KALLISON RANCH
MASTER DEVELOPMENT PLAN

Re: Kallison Ranch Subdivision MDP # 838

The City Staff Development Review Committee has reviewed Kallison Ranch Subdivision Master Development Plan M.D.P. # 838. Please find enclosed a signed copy for your files. Your plan was accepted, however please note the following:

TYPICAL 120' R.O.W. STREET CROSS SECTION
NOT TO SCALE

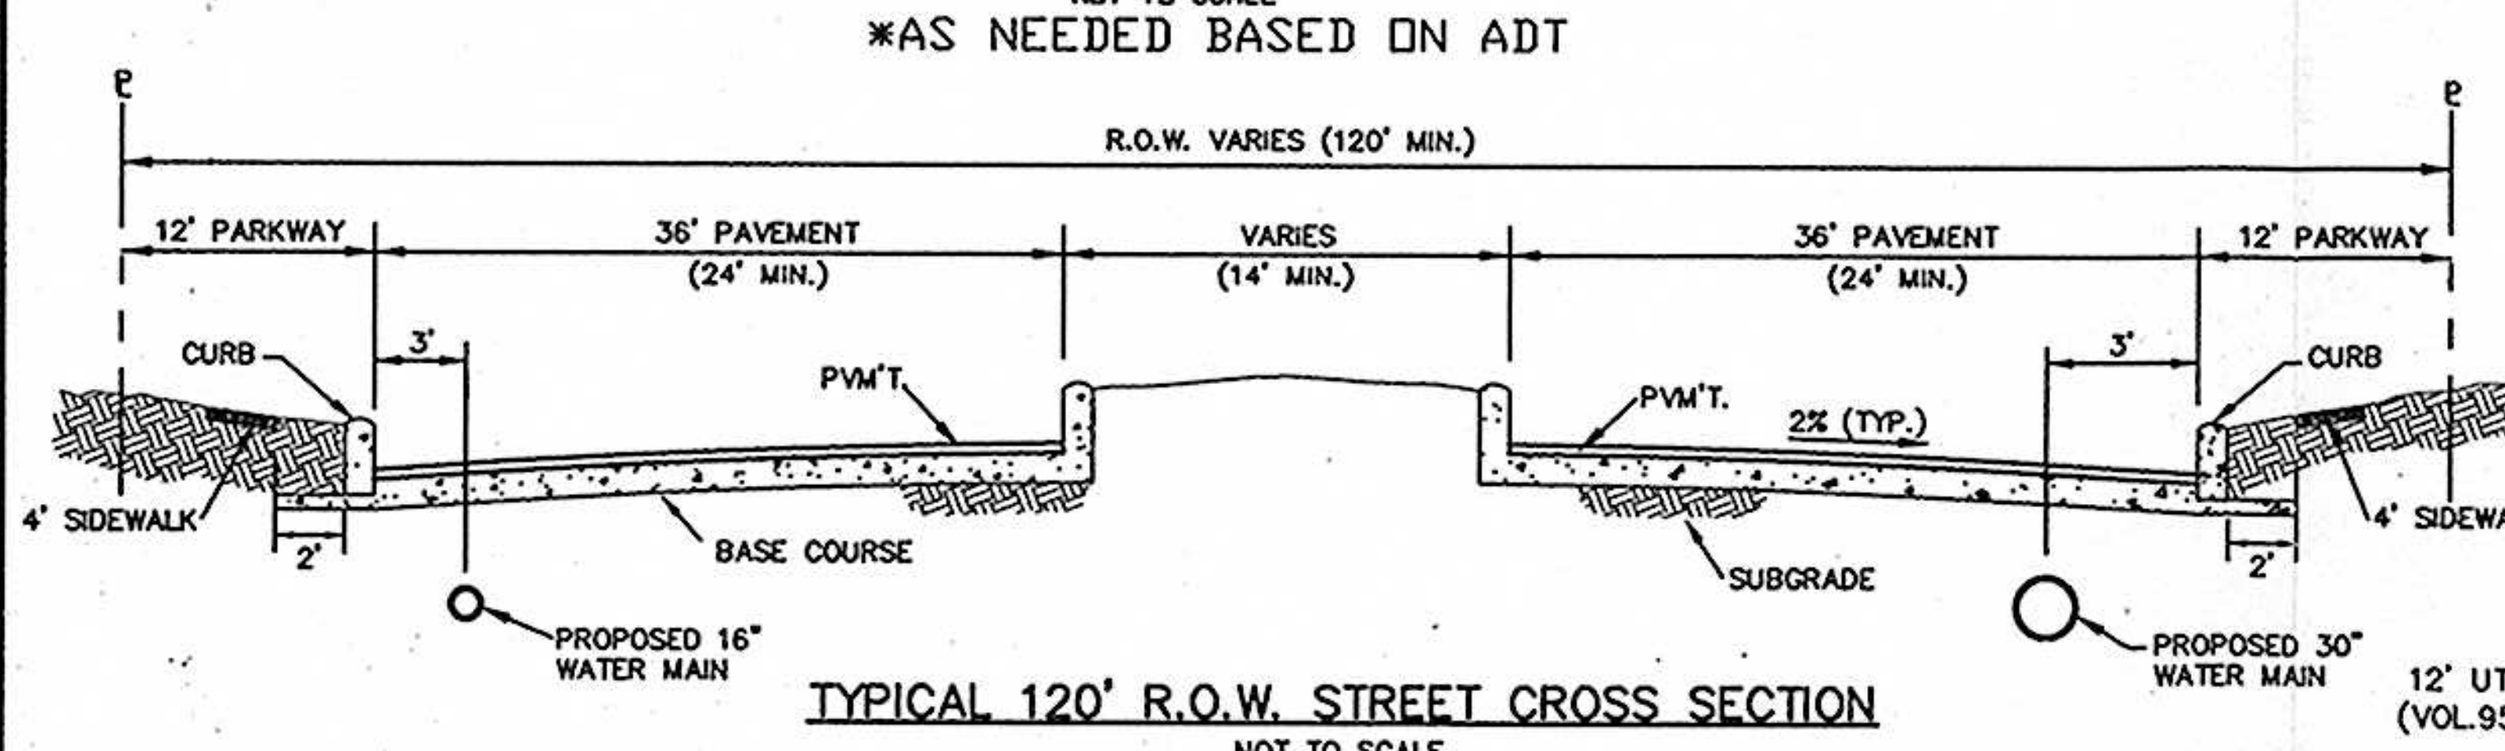
5. ***Existing Talley Road and Talley Road extension (Street 2)*** –Based on the TIA analysis, a minimum of 120-feet of ROW shall be provided at the intersection (existing Talley Road and FM 471), with 70-feet of ROW at the mid block north of Street 1. On street 2 (Talley road extension) 120 feet ROW with separate dual left turn lanes with required storage and bay taper as it relates to the submitted TIA traffic counts and separate right turn lane. On Talley Road, 120 feet ROW with separate dual left turn bays with required storage and bay taper as it relates to the submitted TIA traffic counts and separated right turn lane. On westbound FM 471, construct a deceleration lane with right turn bay and construct dual-left turn lanes with required storage and bay taper as it relates to the submitted TIA traffic counts. On eastbound FM 471 at Talley Road construct deceleration lane and dual left turn lanes with required storage and bay taper as it relates to the submitted TIA traffic counts.

6. ***Street 1/Talley Road (Major Thoroughfare Plan extension)*** – On Street 1, based on the TIA analysis, a minimum of 120-feet of ROW shall be provided at the intersection of Culebra Road to accommodate dual left turn lanes with required storage and bay taper as it relates to the submitted TIA traffic counts. On westbound FM 471, construct a deceleration lane and right turn lane and construct left turn lane with required storage and bay taper as it relates to the submitted TIA traffic counts.

3. The extension of Talley Road into the site will be 70 feet right-of-way, with widening at the intersection with FM 471 to 120 feet to accommodate the necessary turn lanes.

TYPICAL 86' R.O.W. STREET CROSS SECTION
NOT TO SCALE

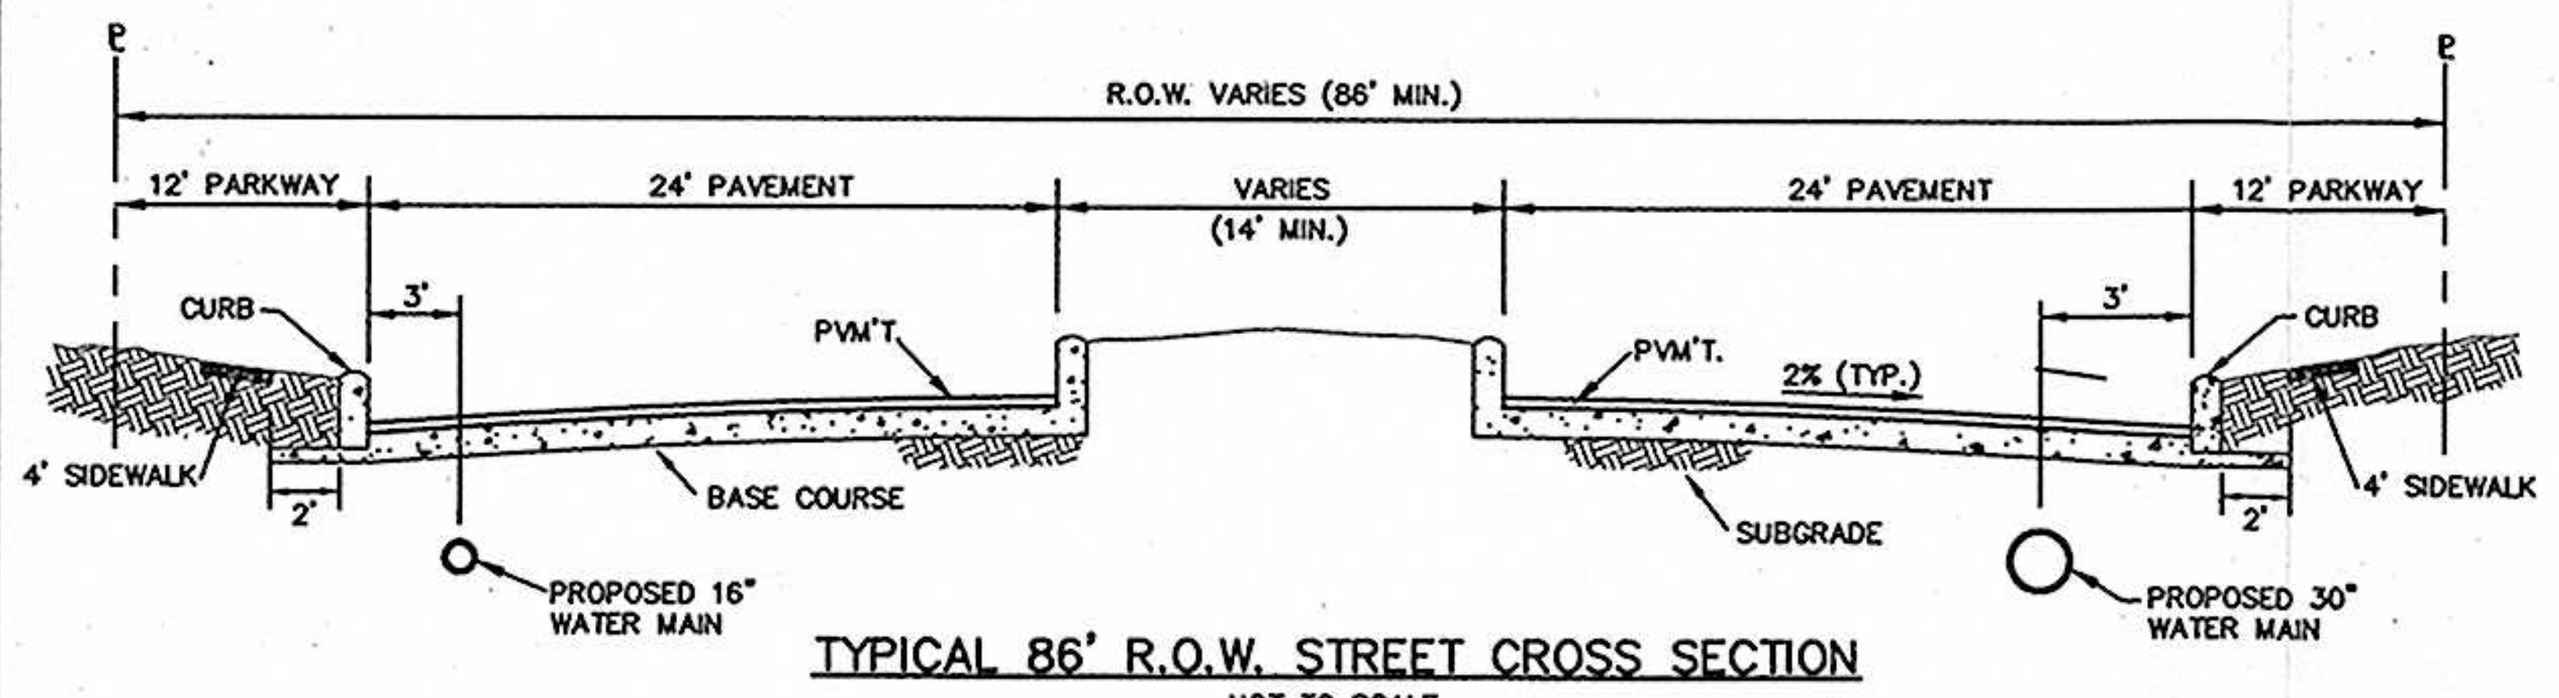
2. ***Street 1 and Street 2 (internal collectors)*** – Construction of an internal collector street system. Collector street design parameters consist of 70-feet of ROW and 44-feet of pavement (Table 506-3). The proposed collector street shall have no houses fronting (UDC 35-515, (c), (4)). The ROW is to be widened to 86 feet at internal intersections to accommodate separate left-turn bays in accordance with TIA requirements. This widening should occur for 300-feet before and after the driveway or intersection along with appropriate ROW transition. Street 2 - construction of an internal Arterial Street System (86-feet of ROW) from FM 471 (Culebra Road) to Street 1 approximately 2100-feet in length.

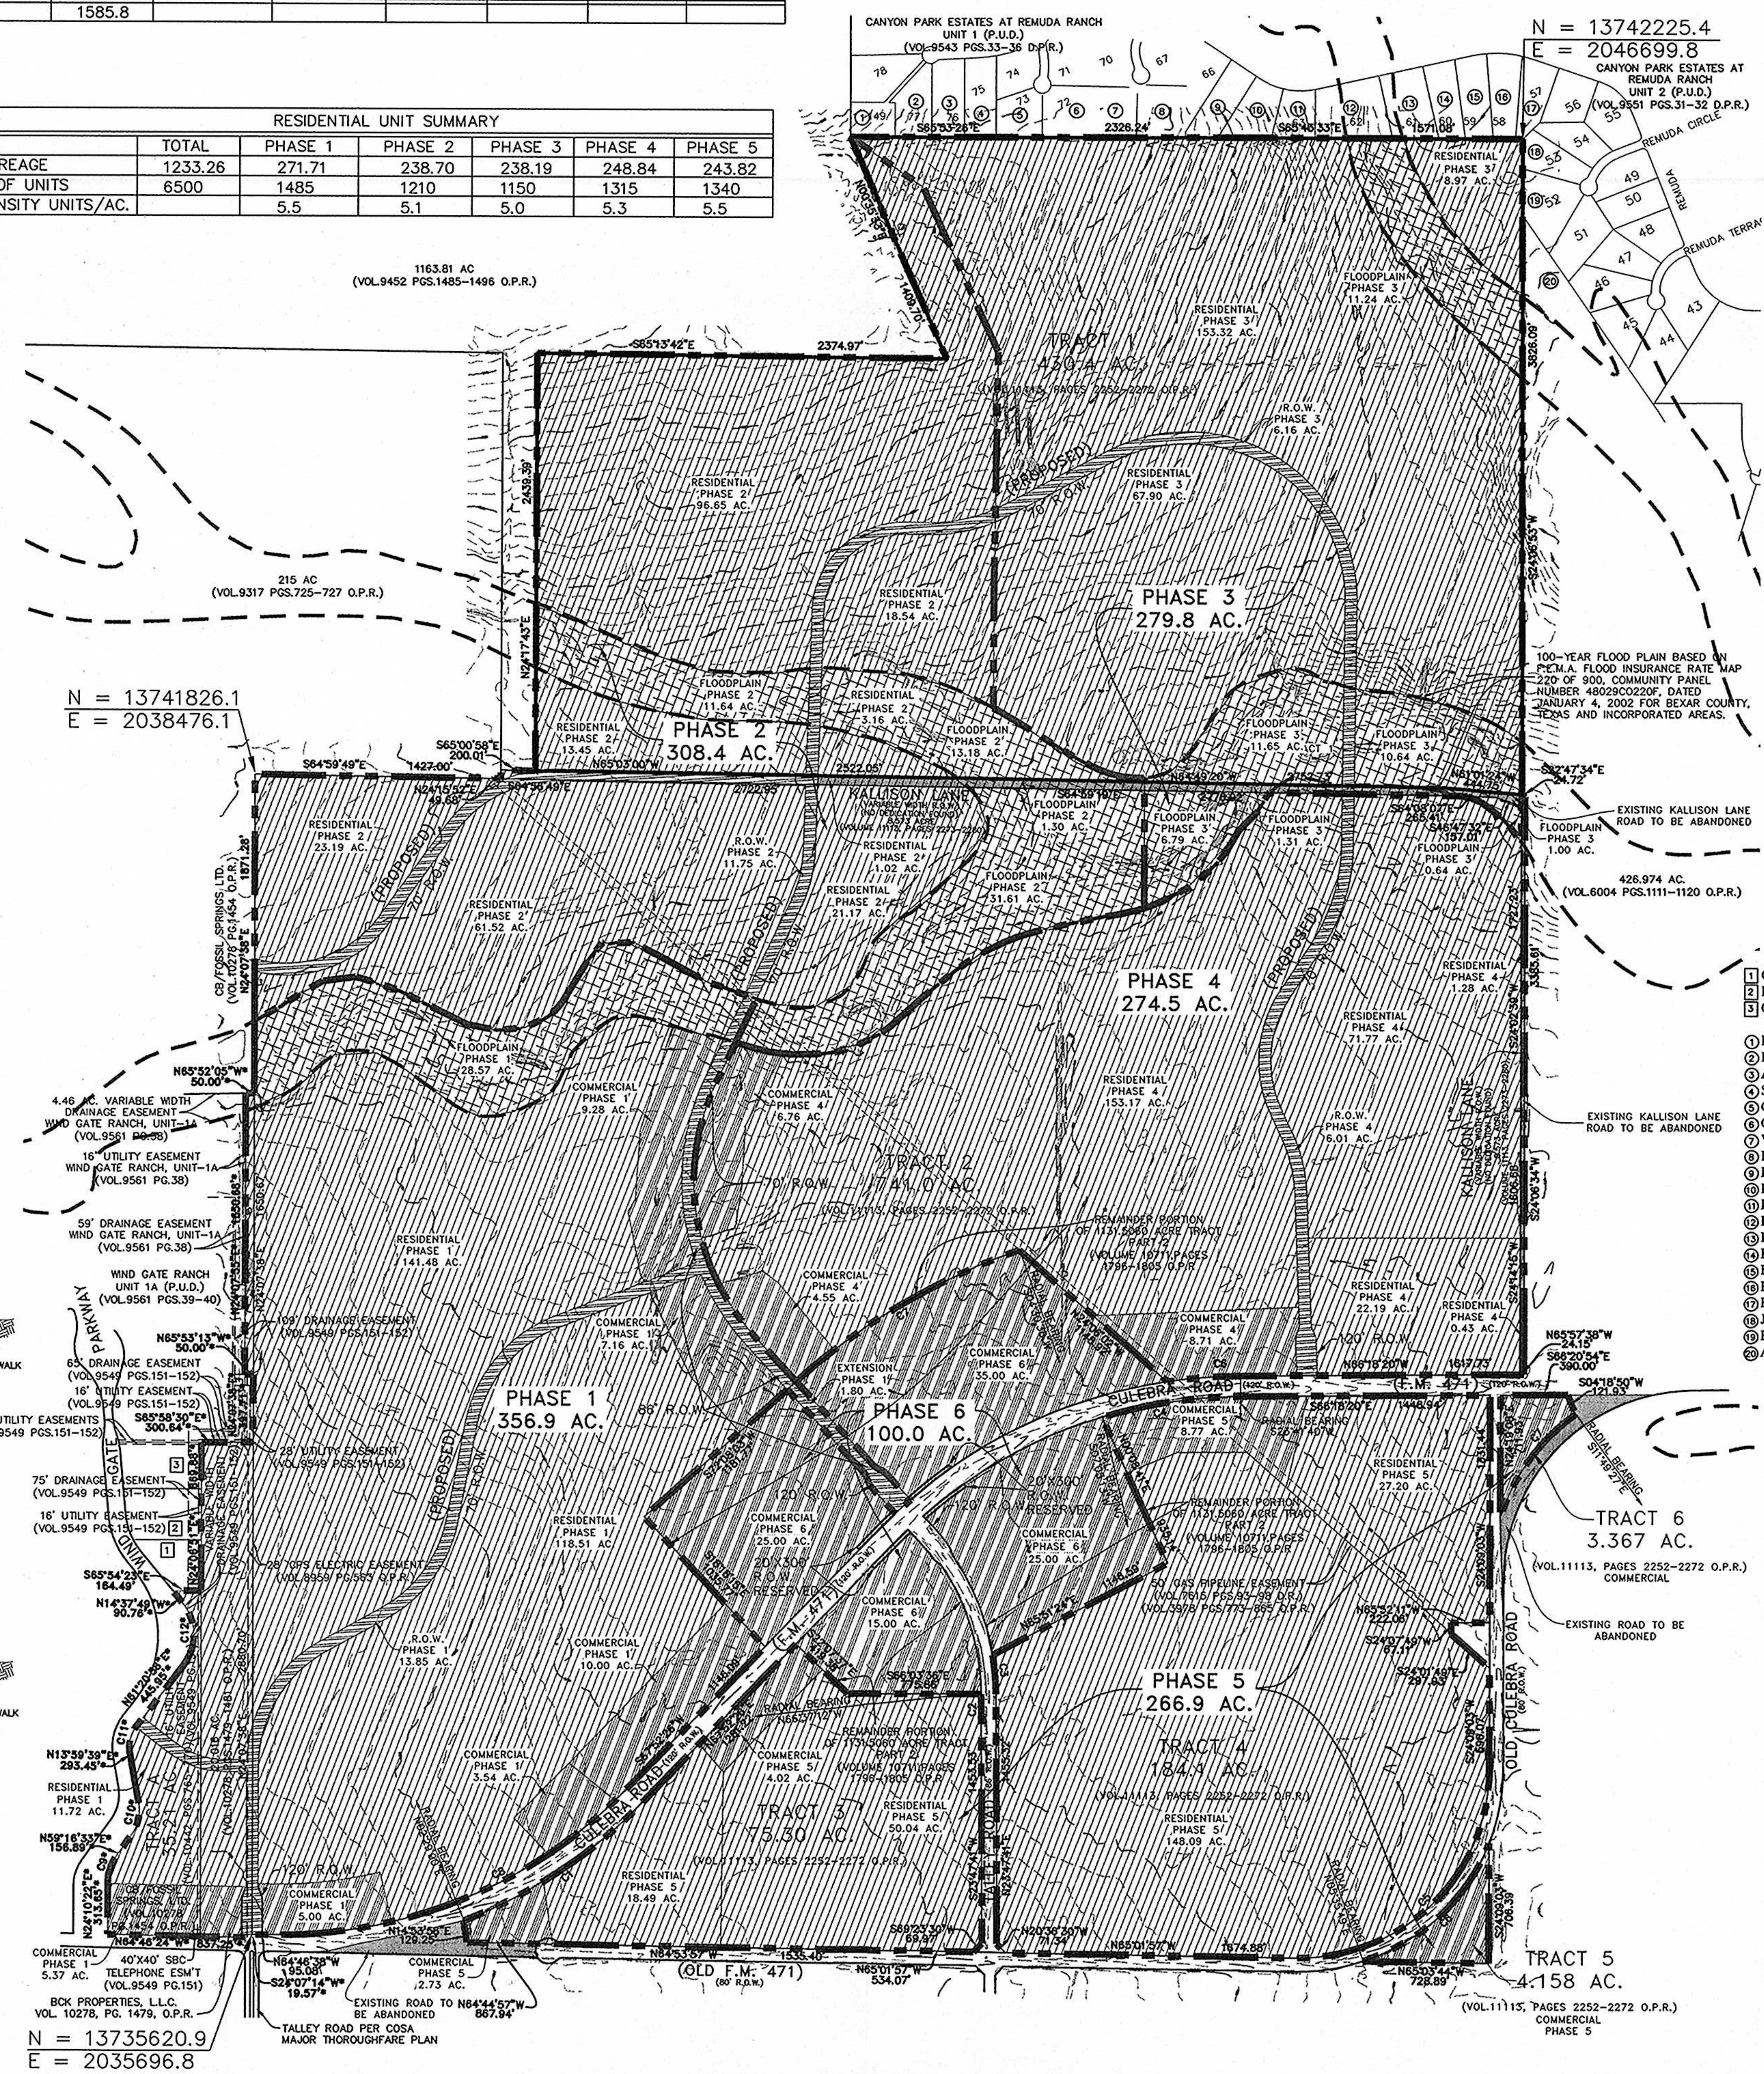
1. **ROW Requirements** – Length of ROW widening for Street 1 and Street 2 at FM 471 (Culebra Road) to comply with left turn bay storage lengths as required by TIA. ROW requirements dictate widened ROW beyond the 200 feet with 100 transition shown on the MDP. Length of ROW widening in accordance with the TIA for Streets 1 and Street 2 at FM 471 to be required at platting.

3. ***FM 471 (Culebra Road)*** – The Developer shall dedicate 60 feet of ROW (Ordinance 98282, October 2, 2003 Major Thoroughfare Plan (MTP)) from the centerline of FM 471 (Culebra Road) (Primary Arterial Type A – Uniform Development Code (UDC) 35-506, (g), (2)) adjacent to this proposed project. Based on the TIA analysis, a minimum of 160-feet of ROW shall be provided at the intersections to accommodate the turn lanes improvements, with 120-feet of ROW at the mid block to accommodate six lanes. The total length of property frontage is approximately 1.6 miles.

12. Revise note 2, "street layouts, phasing, and density are preliminary and change requires resubmittal of the TIA report."

2. Old FM 471 will be realigned at FM 471 East, creating a perpendicular intersection. The diagonal intersection of Old 471 and FM 471 West will be eliminated.
